GROUP BOD	MODEL 2018MY Stinger (CK)
	NUMBER 178	DATE December 2017
TECHNICAL SERVICE BULLETIN		
SUBJECT: SERVICE ACTION: RATTLE NOISE FROM TAILGATE (SA322)

SERVICE ACTION: RATTLE NOISE FROM TAILGATE (SA322)

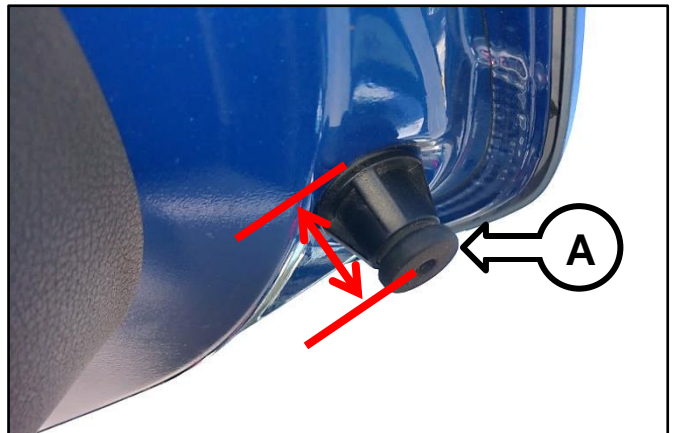
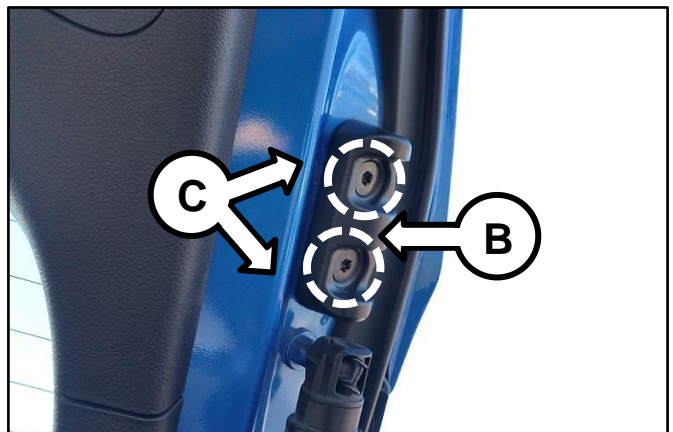
2. Check the overslam bumper (A) and adjust it within the reference protrusion specifications below. Turn the overslam bumper (A) clockwise to decrease distance. Turn it counterclockwise to increase distance if needed.

**Reference protrusion:
0.94 – 1.02 in. (24 – 26mm)**

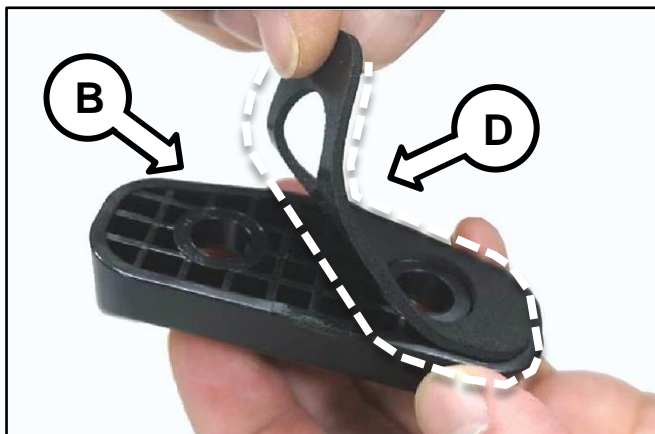
4. Remove the old pad (D) and carefully center and apply the new improved thicker pad onto the guide bumper (B).

Old Pad

New Pad

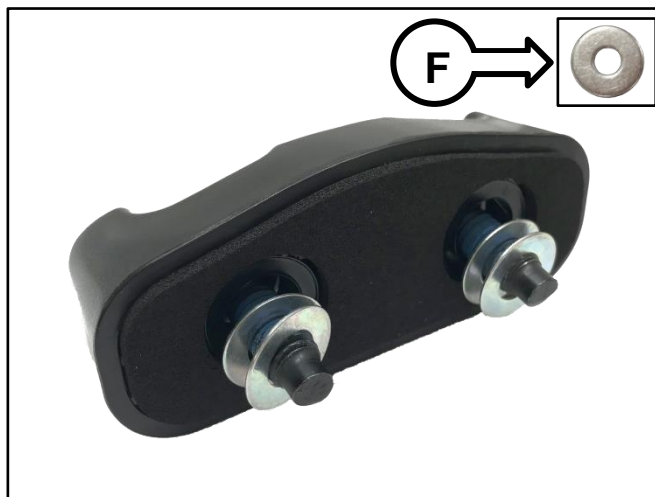
5. Insert two (2) washers (F) per bolt, as shown, and then reinstall the guide bumper (B) onto the tailgate.

**4.3 – 4.7 lb.ft (5.83 – 6.37 N.m,
0.59 – 0.65 kgf.m)**
